CITY OF NEWPORT BEACH

FIRE SPRINKLER ONE AND TWO-FAMILY DWELLINGS PLAN REVIEW COMMENTS

SINGLE-FAMILY - SPRINKLER RISER ASSEMBLY

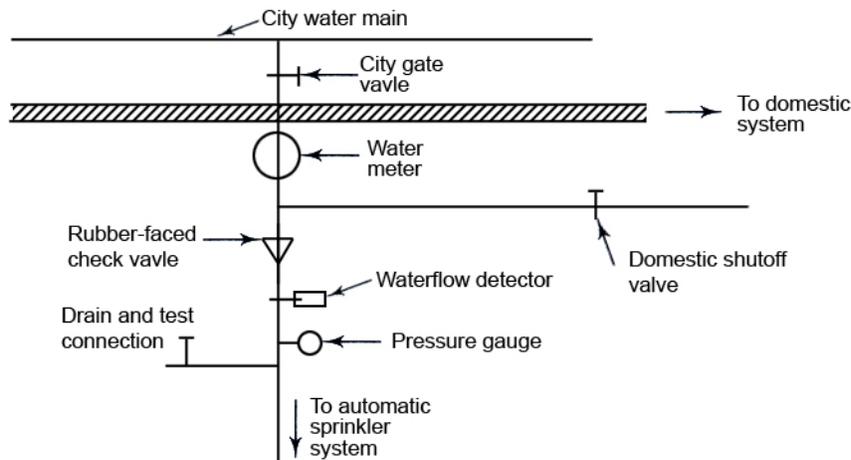
1. Sprinkler Drawings must be prepared, stamped and signed by a licensed civil, mechanical, or fire protection engineer or by a licensed sprinkler contractor holding a valid C-16 license.
2. Coordinate the background and layout of your plans, with the city approved floor plans, ceiling plans, and sections. Consider the most recent city approved revisions with the architect/building designer.
3. Specify the name, license number, address and phone number of the preparer of the sprinkler drawings on the plans.
4. See riser assembly details below. Riser assembly to include:
 - a. Main control valve, which controls the sprinkler system & domestic water supply.
 - b. Domestic water supply valve, which controls the domestic water supply only.
 - c. Pressure gage
 - d. Check valve
 - e. Water flow switch
 - f. Test/drain valve
